CAP Meeting Agenda

ITEM 4.1**DEVELOPMENT APPLICATION – 23015618 – 86A EAST AVENUE, CLARENCE PARK SA 5034**

DEVELOPMENT NO.:	23015618
APPLICANT:	Rossdale Homes
ADDRESS:	86A EAST AV CLARENCE PARK SA 5034
NATURE OF DEVELOPMENT:	Construction of a two-storey detached dwelling and combined retaining wall and fence to a height of 2.2m
ZONING INFORMATION:	<p>Zones:</p> <ul style="list-style-type: none"> • Suburban Neighbourhood <p>Overlays:</p> <ul style="list-style-type: none"> • Airport Building Heights (Regulated) • Building Near Airfields • Prescribed Wells Area • Regulated and Significant Tree • Stormwater Management • Urban Tree Canopy <p>Technical Numeric Variations (TNVs):</p> <ul style="list-style-type: none"> • Maximum Building Height (Metres) (Maximum building height is 9m) • Minimum Frontage (Minimum frontage for a detached dwelling is 9m; semi-detached dwelling is 7.5m; row dwelling is 7m; group dwelling is 22m; residential flat building is 22m) • Minimum Site Area (Minimum site area for a detached dwelling is 350 sqm; semi-detached dwelling is 350 sqm; row dwelling is 350 sqm; group dwelling is 350 sqm; residential flat building is 350 sqm) • Maximum Building Height (Levels

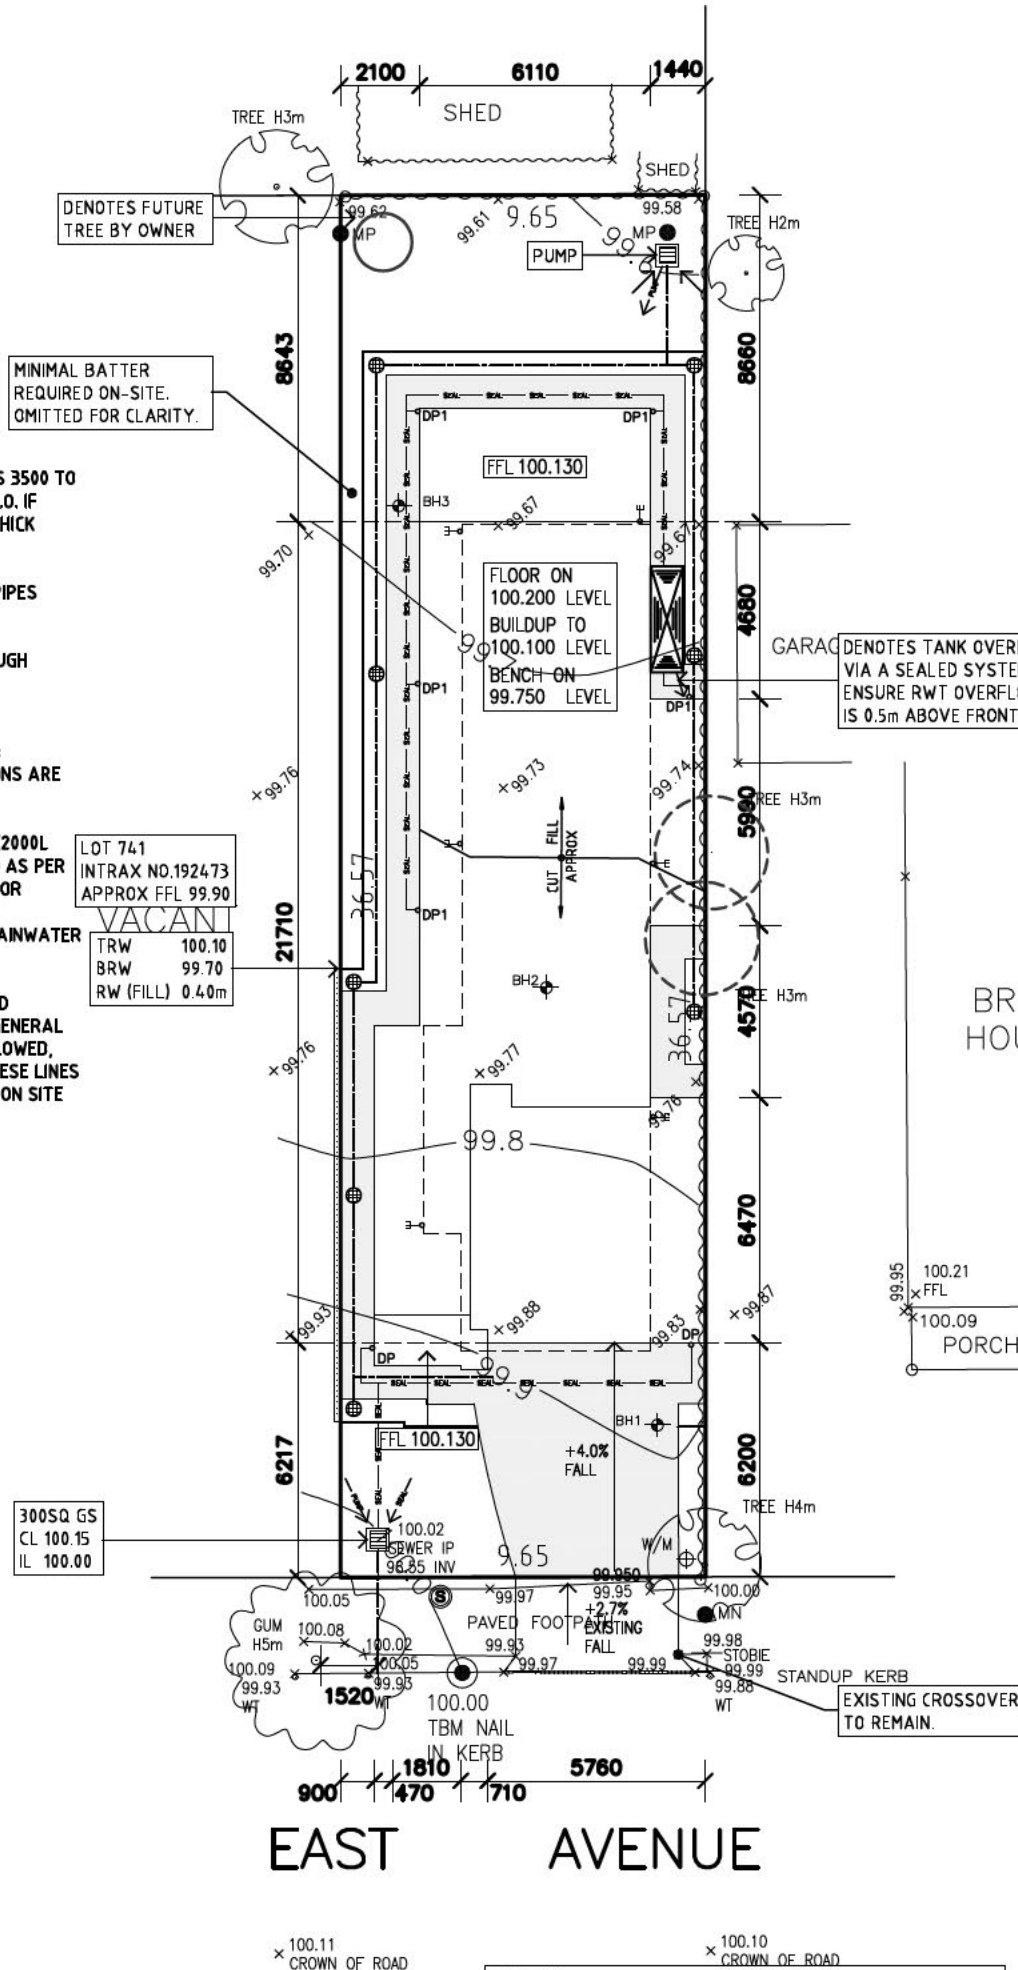
The proposal seeks to install a stormwater outlet within 2m of an existing street tree and therefore was referred to Councils Arboriculture Officer for comment. It was advised that the street trees species is highly susceptible to root damage so their preference would be that the don't trench any closer than 3m from the tree. A Reserved Matter seeking the alteration of the location of the stormwater outlet forms part of the recommendation and agree upon by the applicant.

- An amended Siteworks and Drainage Plan showing the stormwater outlet located a minimum of 3m from the trunk of the street tree, and 0.5m from any street furniture, street pole, infrastructure service pit or other stormwater or utility infrastructure.

FRONT ELEVATION
-TO BE FACE BRICK

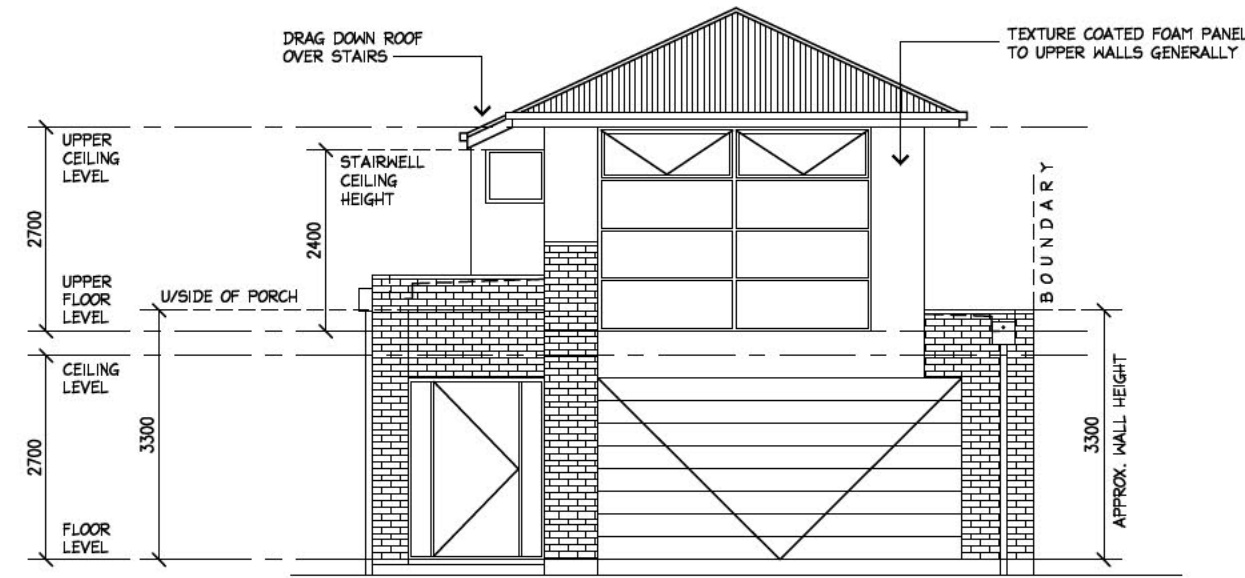
One representor raised concerns with the design and appearance of the proposed dwelling, specifically the garage dominance of the ground level. In this instance the proposal results in a two-storey dwelling that cantilevers the upper level over the ground floor (with the exception of the porch). **DPF 20.1** enables a garage to have a width exceeding 50% of the allotment frontage when there is a second building level. Notwithstanding this, due to the articulation of the dwelling, the cantilevered upper level and the use of a variety of materials to the façade, it is considered the dominance of the garage has been mitigated and will

The diagram on the property fence show a house from boundary to boundary with two garages and a small door as the frontage.

We would suggest the house be modified to have one garage with another garage/area behind the frontage garage to allow for two car storage, or if used as per normal use, or how the vast majority of owners use them, one garage and one storage area.

With regards to Representor 3, from [REDACTED], they have not read the plans correctly as they have commented about the house being boundary to boundary, which it clearly is not. They have also made comments about the garage being used as a storage room and therefore cars will be parked in front of the garage, along the driveway. This is a huge assumption without knowing that my clients fully intend on using their garage as that. The development also states that a double width garage door is allowed on a double story and therefore all of the comments of this representor is uneducated and council should not be taking it into their consideration.

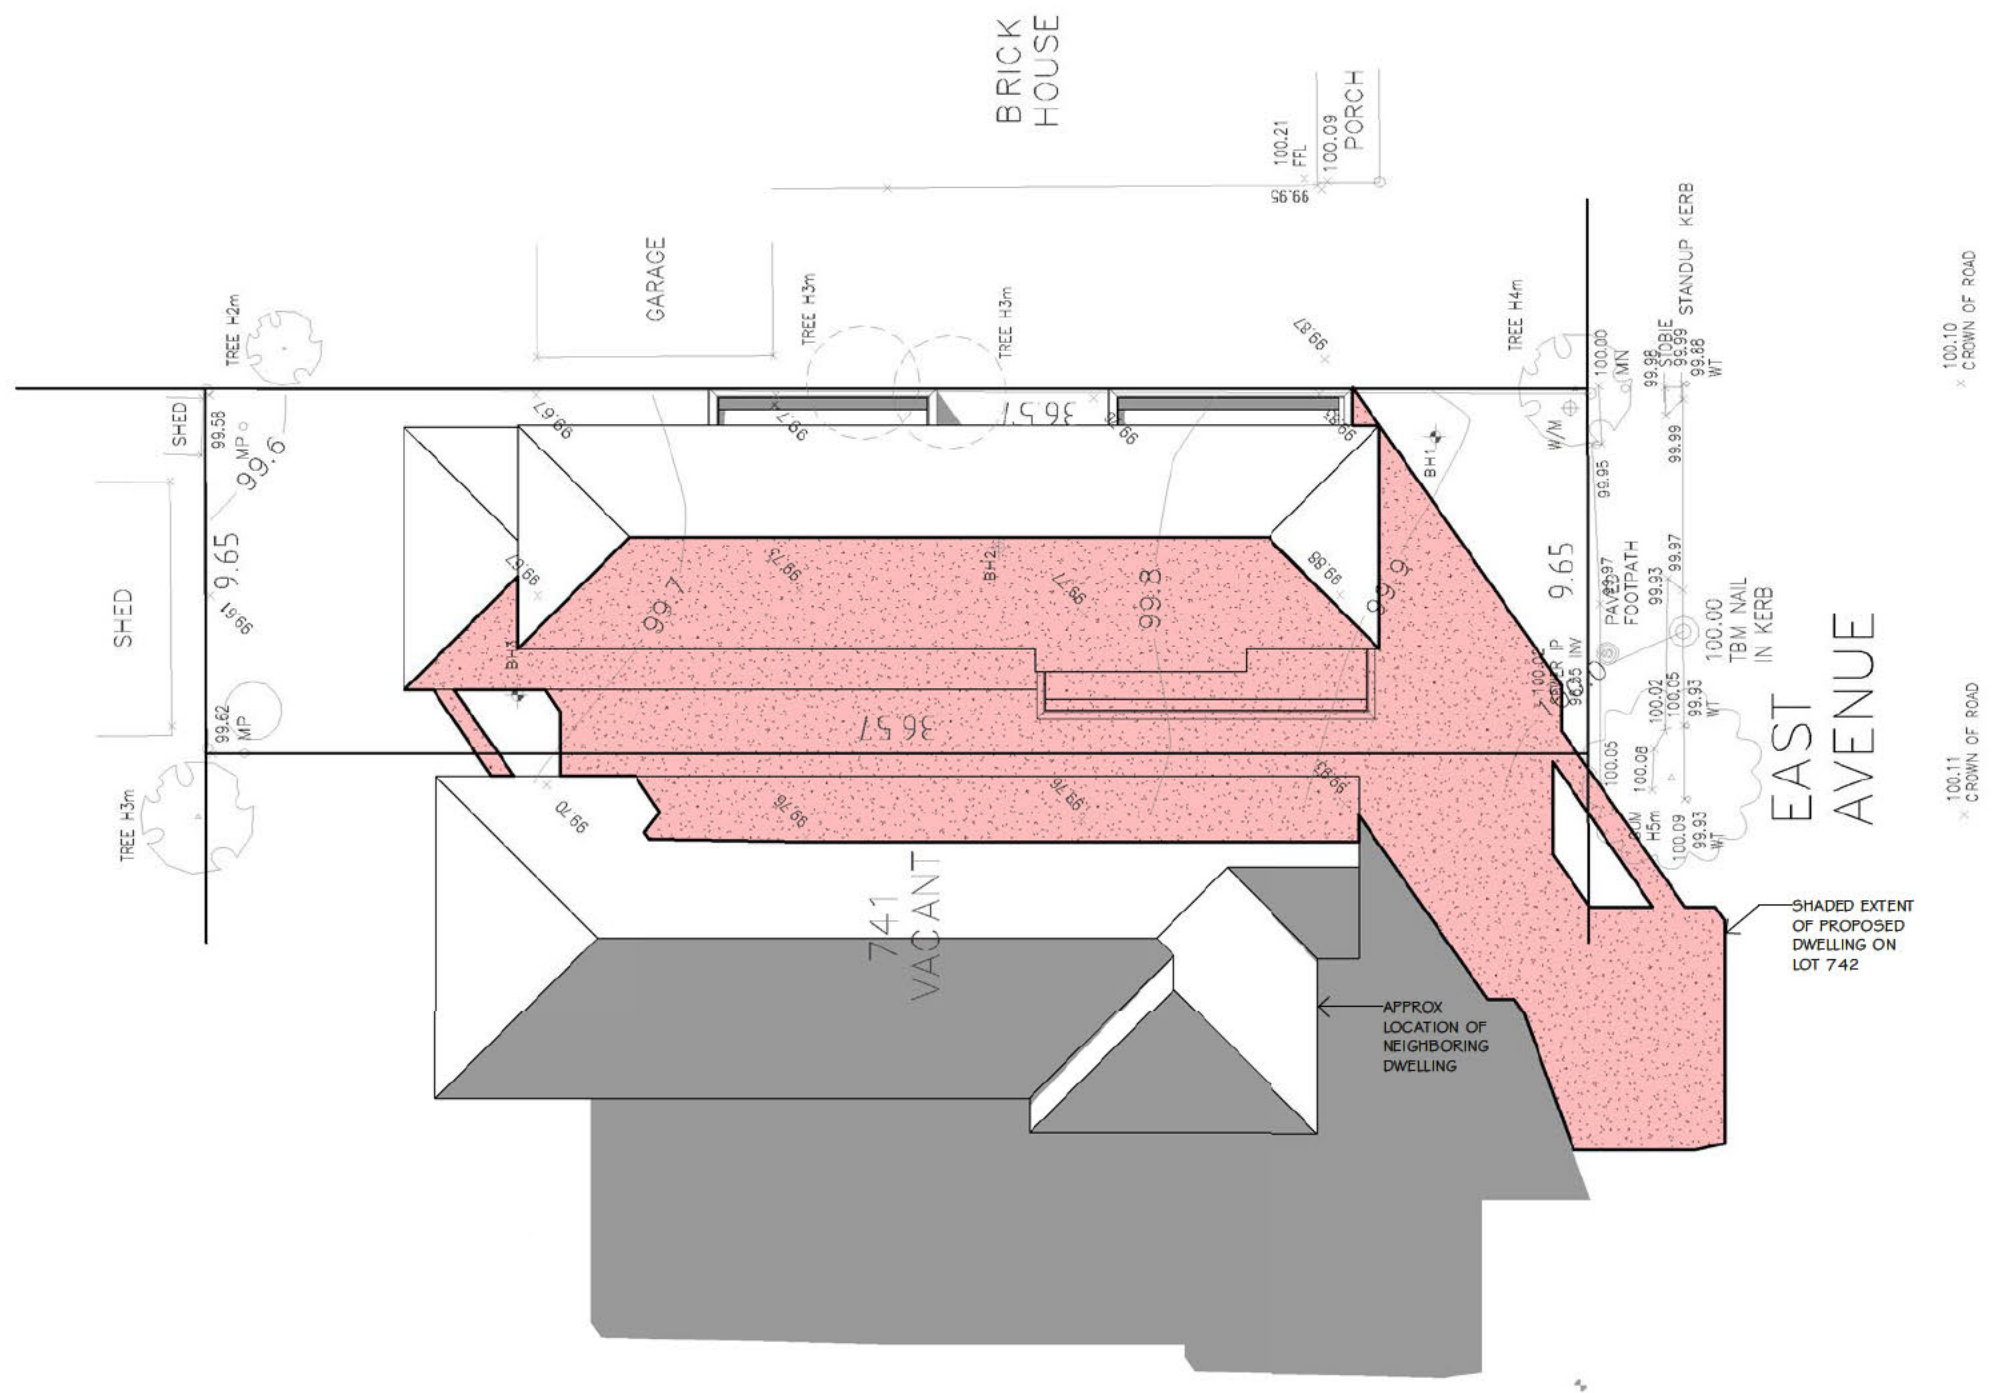
The applicant provided a series of overshadowing diagrams for 9am, 12pm and 3pm during the winter solstice, which take into consideration the vertical height of the adjoining dwelling at 86B East Avenue. The adjacent land contains a single storey detached dwelling, with the master bedroom, ensuite, study, laundry, bathroom and dining area provided with north facing windows.

The **Suburban Neighbourhood Zone PO 2.1** and **PO 8.1** generally seek one - two storey dwellings, with the proposed dwelling requiring an upper-level setback between 2.7-2.8m from the southern boundary to manage bulk, scale and shadow impacts to adjoining sensitive receivers. The diagrams show that on the winter solstice, the north facing windows to the study of the adjoining dwelling will be shadowed for the entirety of the day.

Notwithstanding the above, the proposed dwelling will maintain at least 3 hours of direct winter sunlight to the master bedroom and dining area of the adjoining dwelling. The dwelling provides sufficient side setbacks to maintain access to natural light and ventilation through to the adjoining dwelling.
